# Teven Quarry Blast Management Plan

Holcim Australia  
September 2021

**Teven Quarry (SSD-6422)  
Request for Additional Information**

Attachment A  
Teven Quarry  
Blast Management Plan Reviews – Oct 2020

**Figure 1**

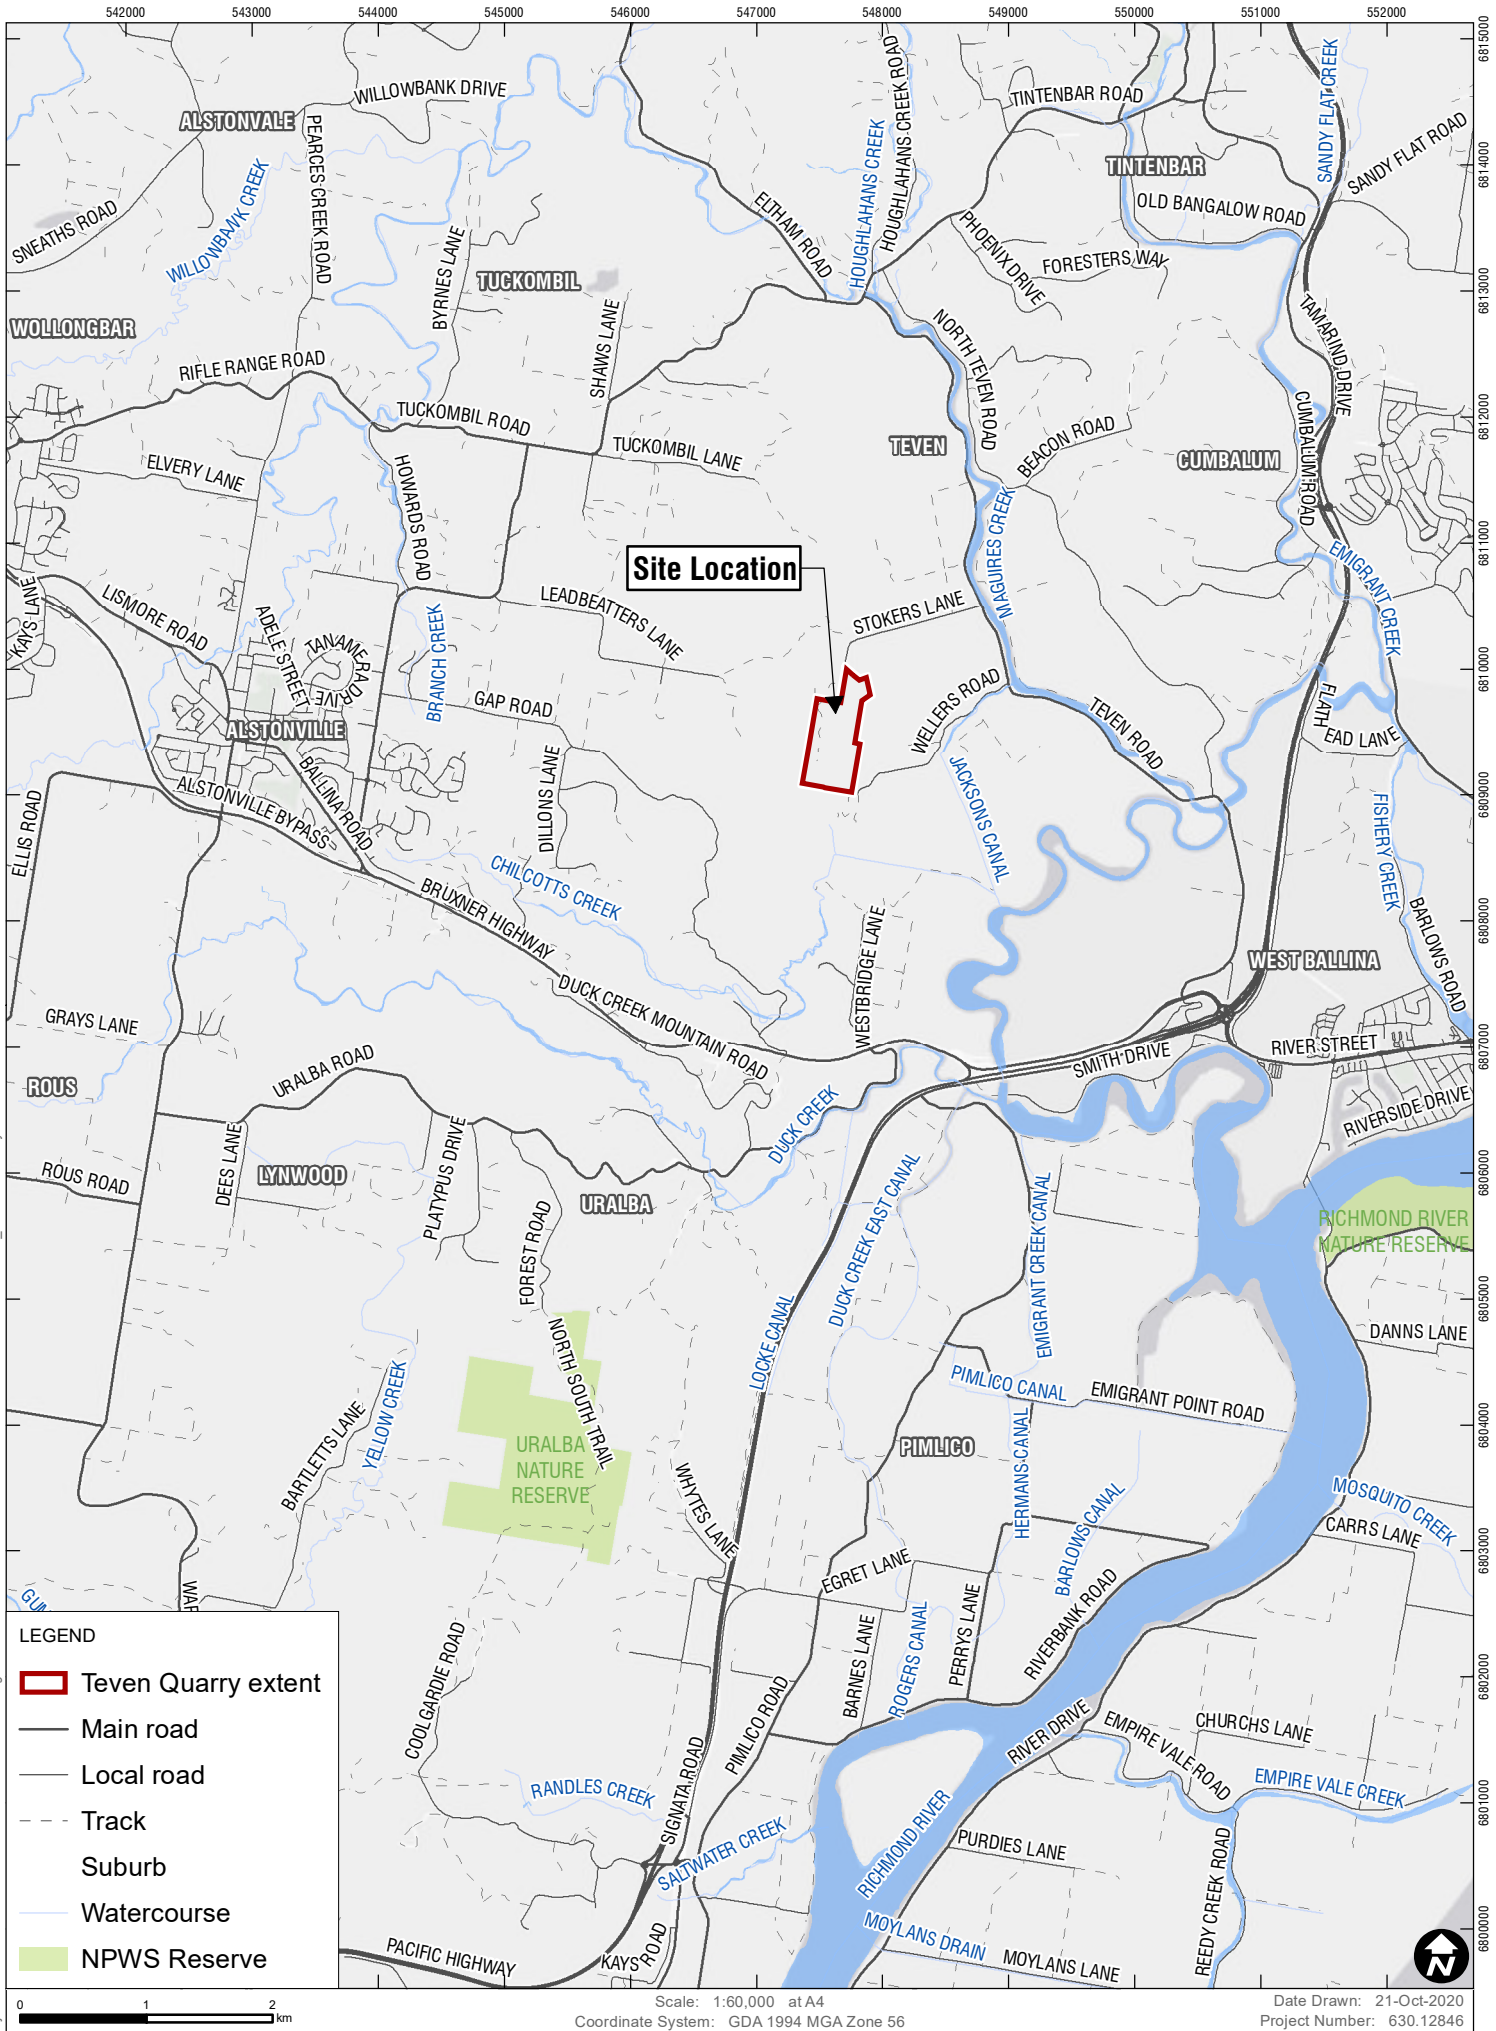
<b>Other Comments on Blast Management Plan</b>	<b>Holcim Response</b>
<ul style="list-style-type: none"> <li>The BMP is not to an acceptable standard.</li> <li>Figure 1 location does not show the current location of the Pacific Highway.</li> <li>S.9.3 What is INX?</li> </ul>	<ul style="list-style-type: none"> <li>The previous BMP (EMM, 2016) as a reference document in Table 7.</li> <li>Figure 1 has been updated.</li> <li>INX has been expanded.</li> </ul>
